PROJECT: Phase I Parking Garage, Portland International Jetport, Portland, ME

Job Name: Portland Jetport, Phase I Parking Garage, Contract 3

BUILDING PERMIT APPLICATION

Portland Jetport Parking Garage Contract 3

1 ELEVATION @ GUARD RAIL
1/2"=1'-0"

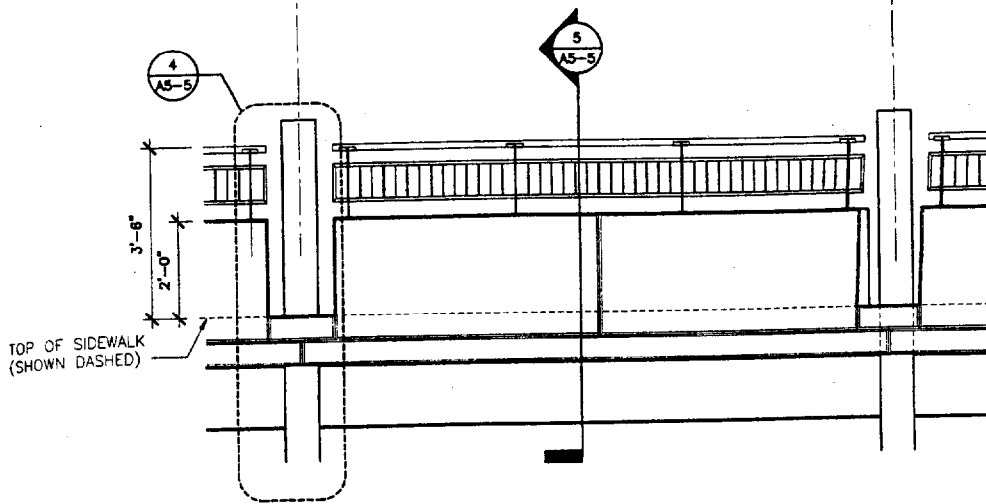
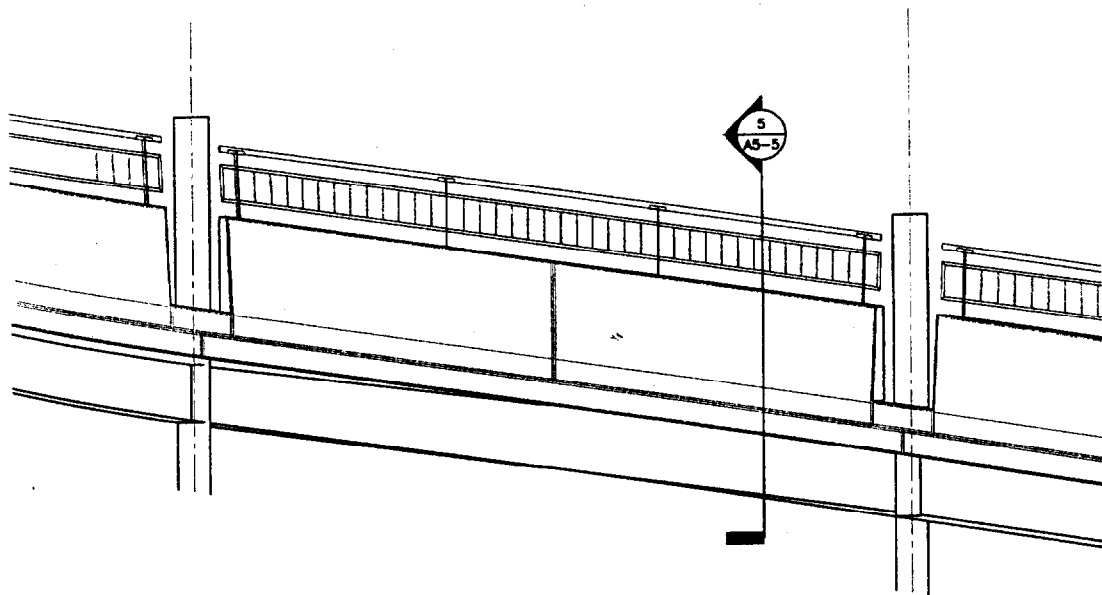
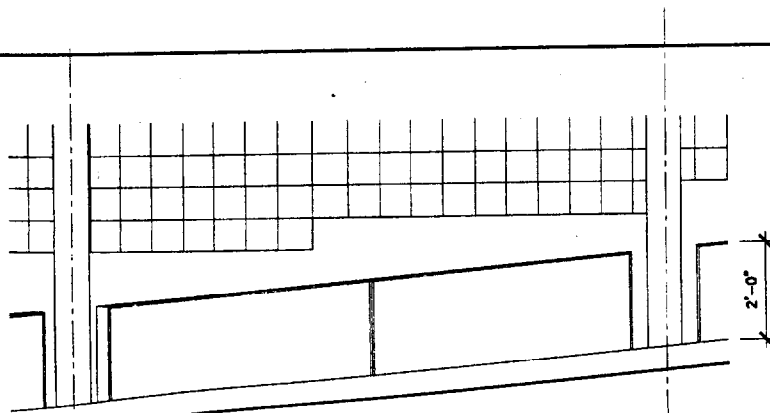
Please take a look at this guard for a 5 story open parking structure, is there a ladder issue in your opinion?

1/16/02
BOCA ADVISES THAT
GUARDS MEET THE
INTENT OF THE CODE
(Signature)
